SACRAMENTO ARCHITECTS COLLABORATIVE
722 Alhambra Boulevard
Sacramento, California 95816

ADDENDUM #1

SACRAMENTO COMMUNITY CENTER COMPLEX

13th and 14th Streets,
J and L Streets,
Sacramento, California

① BALCONY & BOX FRONT RAIL
SCALE 1/4" = 1'-0"

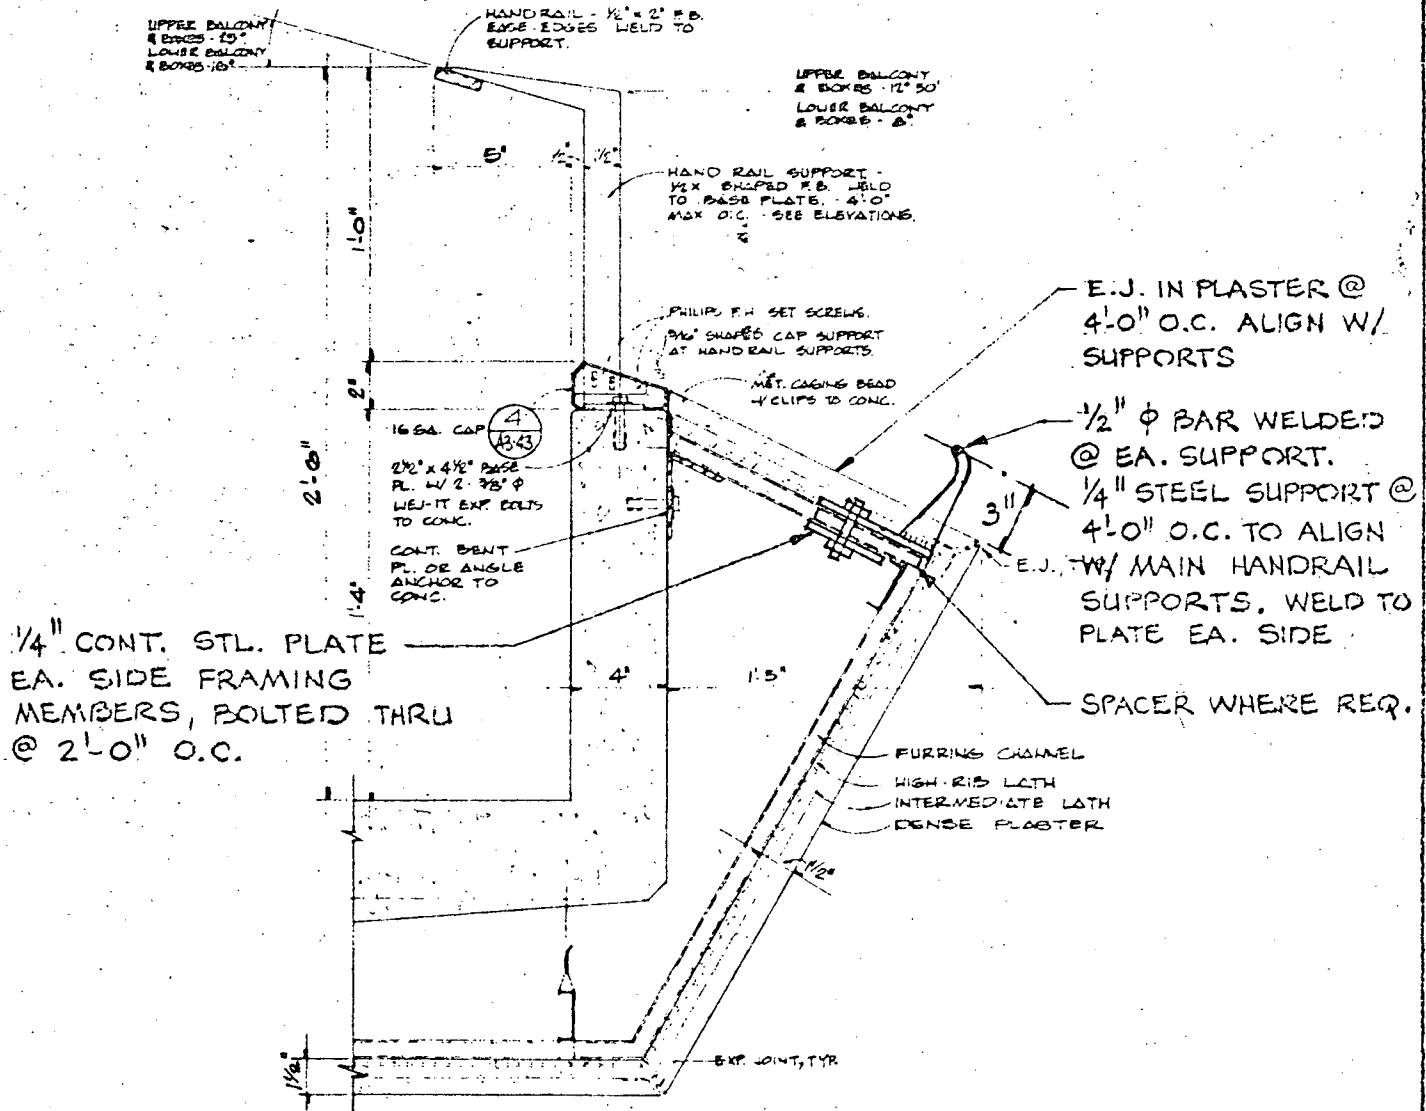
BALCONY GRAB BARS

Reference: Drawings - Sheet A3-43
Addenda Drawing No. 1
Specifications - Volume I
SECTION 5E - MISCELLANEOUS METAL
Page 5E-1

"Delete Detail 1 on Sheet A3-43." Replace that detail with
Addenda Drawing No. 1.

Include material under Handrails and Railings in Section 5E.
